Sundry Print Report

Well Name: WINIFRED COM Well Location: T30N / R14W / SEC 25 / County or Parish/State: SAN

Notice of Intent

Notice of Intent - Plug and Abandonment

Planned P & A Wellbore Schematic

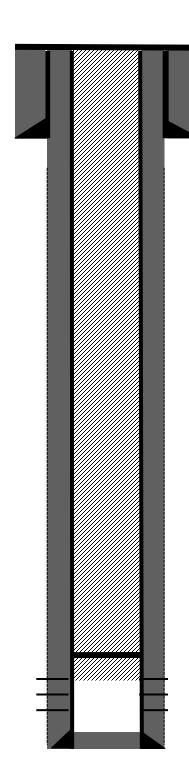
- 1. Plugging operations authorized are subject to the attached "General Requirements for Permanent Abandonment of Wells on Federal and Indian Lease."
- 2. The following modifications to your plugging program are to be made:
 - a. Complete well bore fill up proposal. No changes to the procedure.
- 3. <u>Notification:</u> Farmington Office is to be notified at least 24 hours before the plugging operations commence at (505) 564 7750.

Complete wellbore fill up proposal. No changes to the procedure.
